14 CCD#11 07/03/25

LIGHTING PLAN AND DETAILS

WALMART #2403 GENERAL REMODEL

ELECTRICAL ONE-LINE, **DETAILS AND** SCHEDULES

PICKUP STORAGE **POWER** PLAN, NOTES AND DETAILS

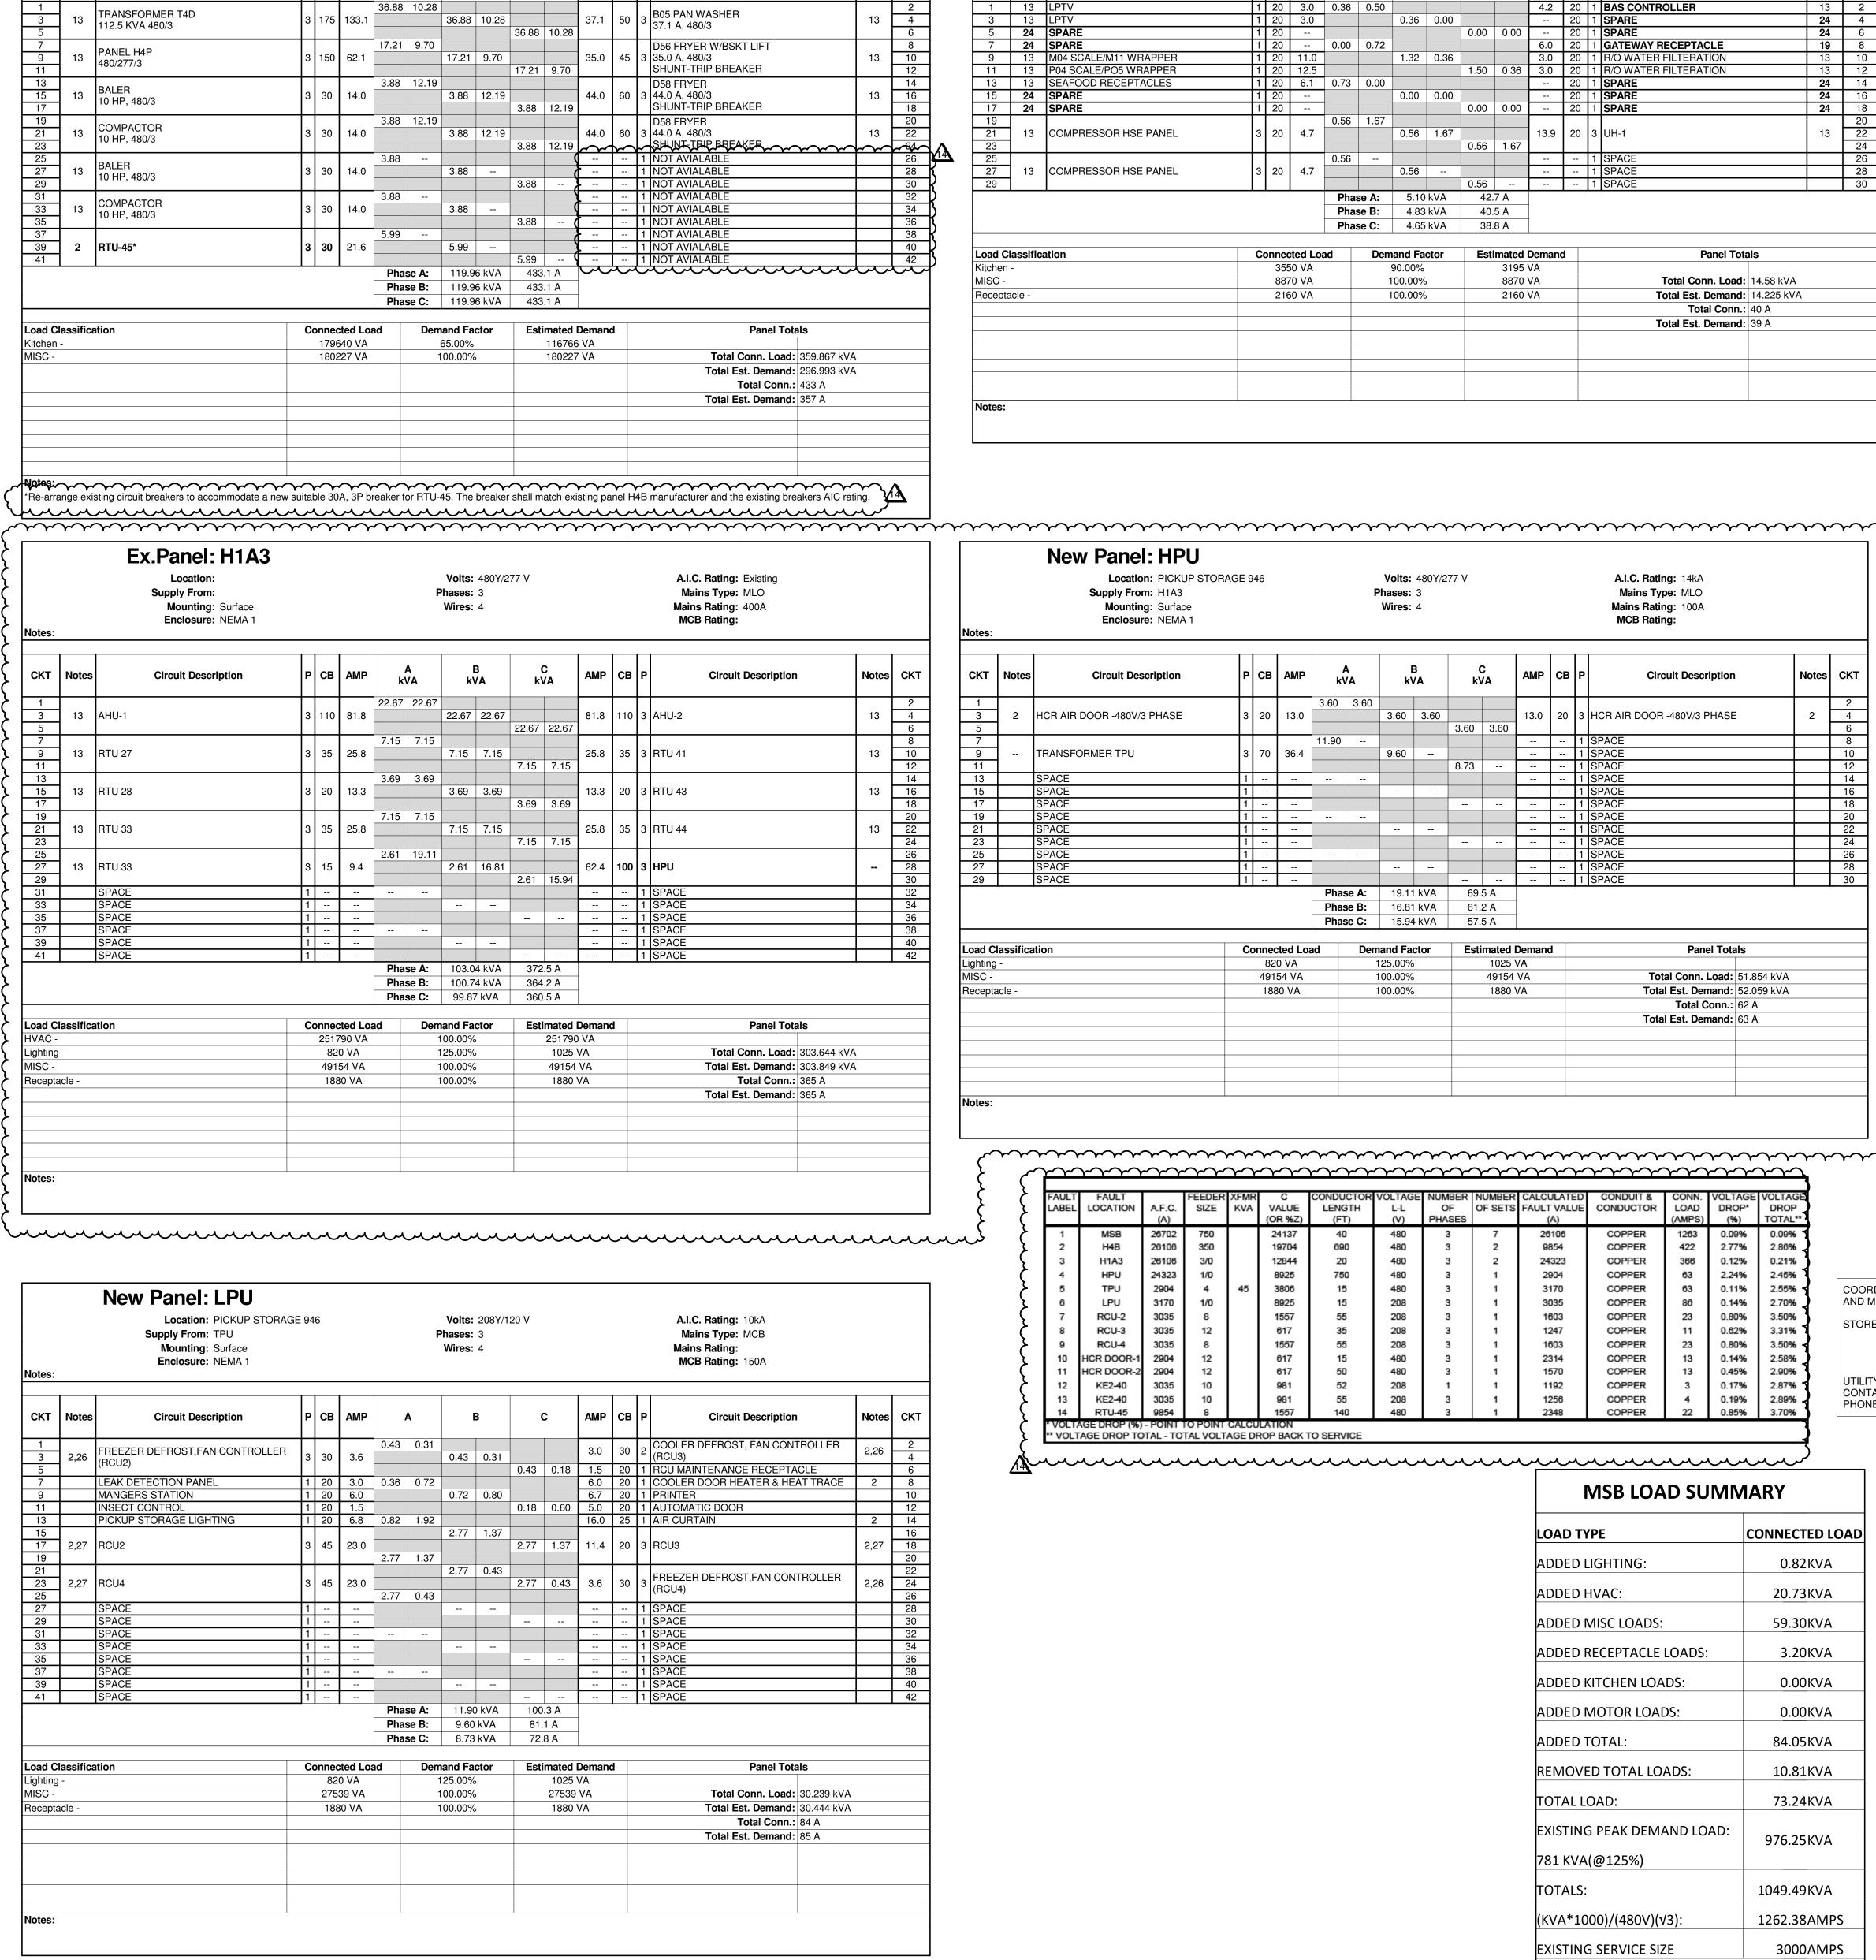
07/03/25
